Z-35
(2014)

PETITION NO: Z-35

ZONING COMMENTS:

STAFF RECOMMENDATIONS

| <p>DUCKSON ENGINEERING 2018 PINEHURST DRIVE ALPHARETTA, GA 30009 770.940.8888 WWW.DUCKSON.COM</p> | | PROJECT NAME: JAMERSON ROAD SUBDIVISION DRAWING TITLE: ZONING PLAN | DRG NO.: Z01 DATE: 04/03/14 DRAWN BY: [Name] CHECKED BY: [Name] |

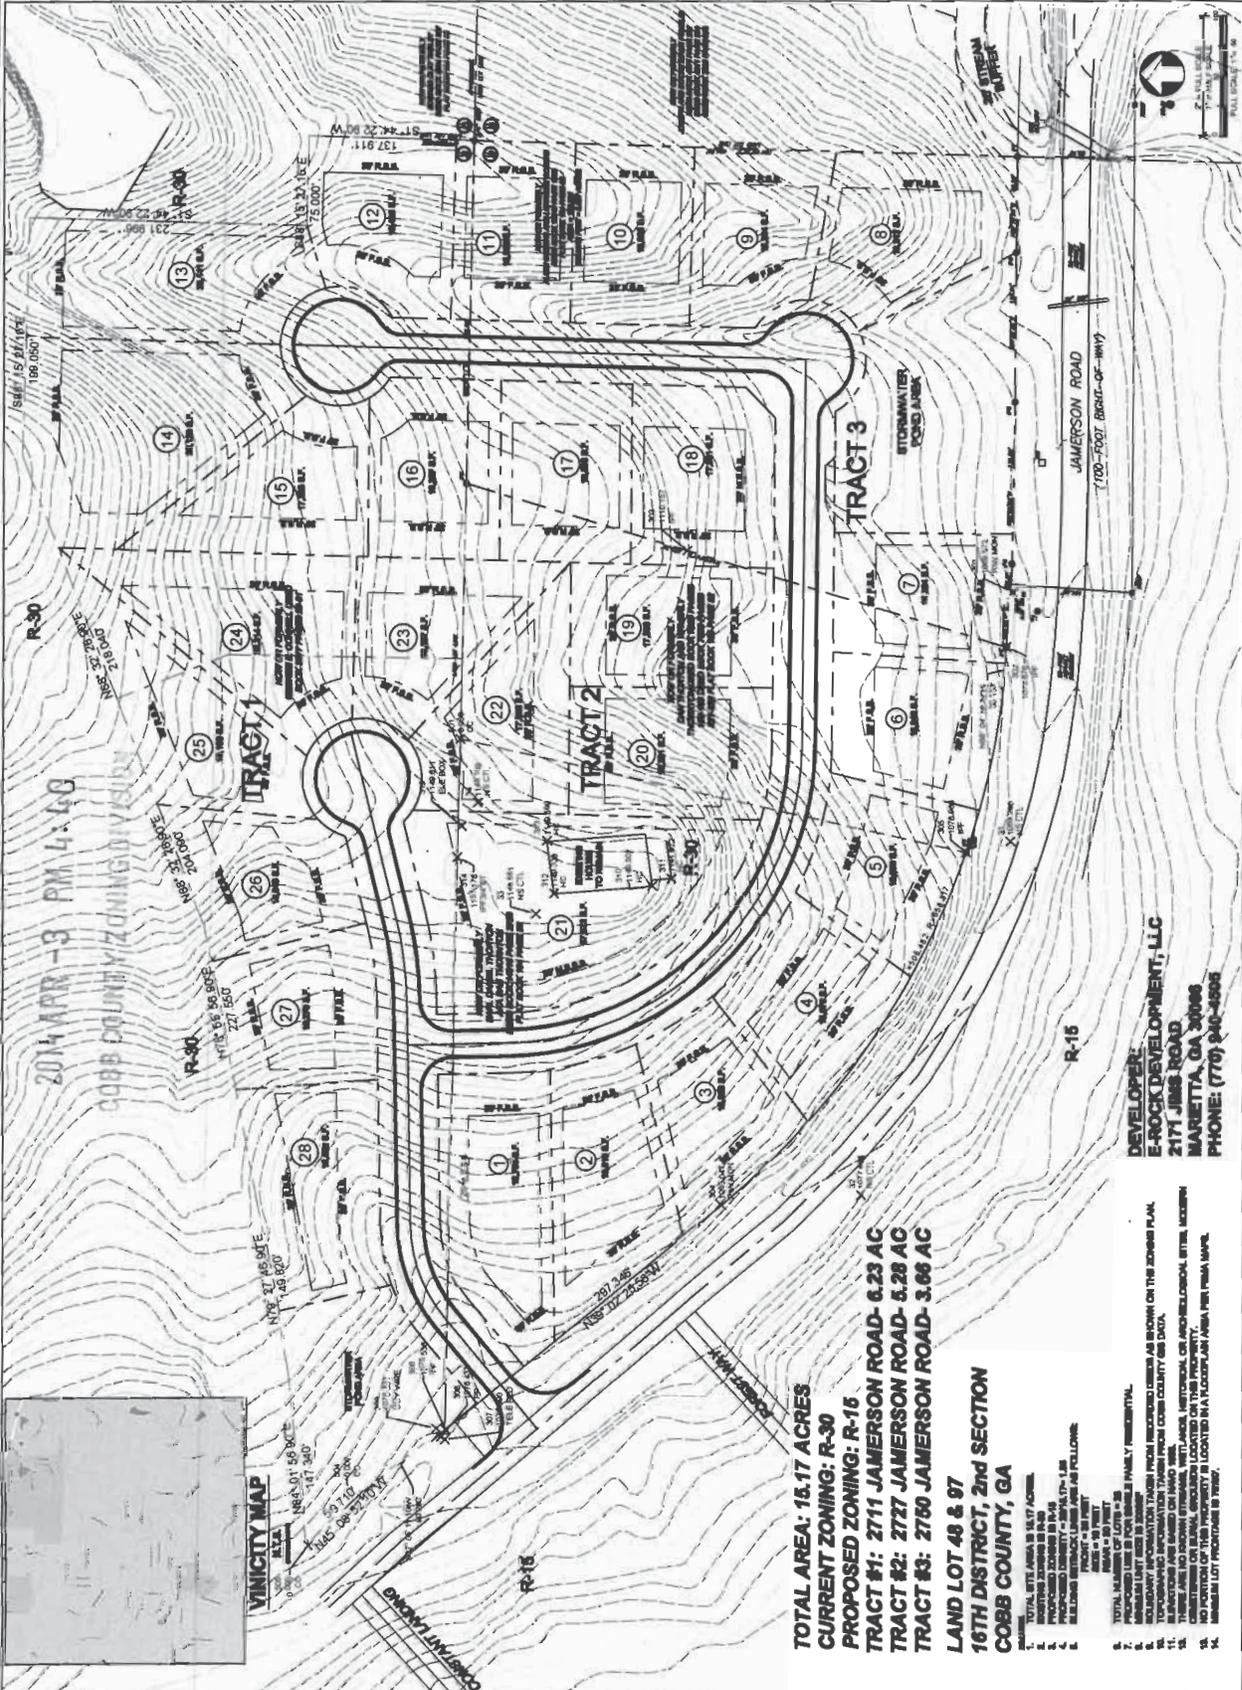
- Project engineer must evaluate the impact of increased volume of runoff generated by the proposed project on downstream receiving system. Limited channel conveyance through Forest Chase S/D must be evaluated and may impact allowable discharge capacity of westernmost detention pond.

- Provide comprehensive hydrology/stormwater controls to include development of out parcels.
- Submit all proposed site improvements to Plan Review.
- Any **spring activity** uncovered must be addressed by a qualified geotechnical engineer (PE).
- Structural fill _____ must be placed under the direction of a qualified registered Georgia geotechnical engineer (PE).
- Existing facility.
- Project must comply with the Water Quality requirements of the CWA-NPDES-NPS Permit and County Water Quality Ordinance.
- Water Quality/Quantity contributions of the existing lake/pond on site must be continued as baseline conditions into proposed project.
- Calculate and provide % impervious of project site.
- Revisit design; reduce pavement area to reduce runoff and pollution.

- No Stormwater controls shown _____
- Copy of survey is not current – Additional comments may be forthcoming when current site conditions are exposed.
- No site improvements showing on exhibit.

1. The subject parcel is located to the north of Jamerson Road just west of its intersection with Wigley Road. Slopes on the site are moderate to steep with average slopes ranging from 20 to 30%. While the entire parcel drains to the south to Jamerson Road, the site is divided by a ridge that splits the site with approximately three-quarters flowing to the southeast corner and the remaining quarter to the southwest corner. Both discharge points drain to existing culverts under Jamerson Road. Detention ponds will be required at both locations to control stormwater runoff from the site.

- E. It is Staff's opinion that there are existing and changing conditions affecting the use and development of the property which give supporting grounds for deleting the applicant's rezoning proposal. While the current proposal meets the R-15 and LDR requirements, Staff feels that the topography of the property may present difficulties in the development process. Staff believes that by applying the density average of 1.75 units per acre from the Zoning Ordinance for the R-20 category, applicant can possibly achieve 26 lots, decreasing the proposed R-15 development by two lots.

Based on the above analysis, Staff recommends DELETING the request to the R-20 zoning category subject to the following conditions:

- Site plan meeting R-20 requirements, with the District Commissioner approving minor modifications;
- Water and Sewer Division comments and recommendations;
- Stormwater Management Division comments and recommendations; and
- Department of Transportation comments and recommendations.
